Memo To: Prospective Bidders
From: Dale M. Foster, PE, County Engineer 
Re: **CAPE MAY COUNTY BRIDGE COMMISSION**
OCEAN DRIVE (CR619) OVER TOWNSENDS INLET
RAILING REPLACEMENT
ADDENDUM NO. 1

ADDENDUM NO. 1

OCEAN DRIVE (CR619)
OVER TOWNSENDS INLET - RAILING REPLACEMENT
STR. 3100-003

ATTACHMENT NO. 1

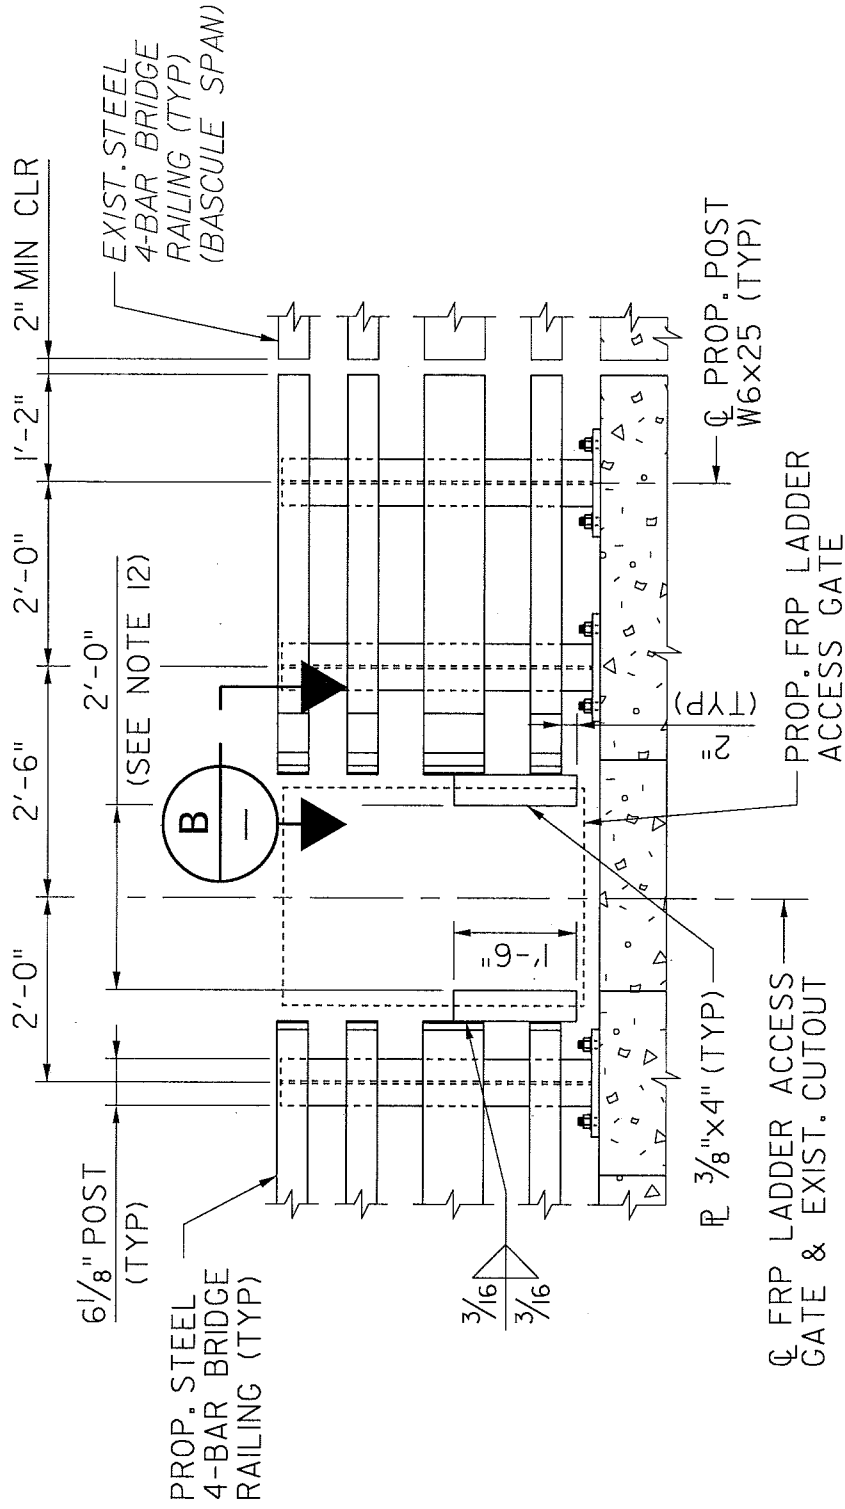
In the SPAN 10 PLAN, the 2'-0" and the 2'-6" dimensions near the ladder are deleted. All of the details and dimensions for this location are revised and superseded by Attachments No.1 and No. 2.

Sheet 11 of 21, Deck Plan – 6: *Detail 2 shall be revised and superseded as shown in Attachment No. 1*

REPLACES DETAIL 2 ON SHEET NO. 11: REVISED POST LOCATIONS AND DEPICTS BEND TRANSITION FOR RAILING.
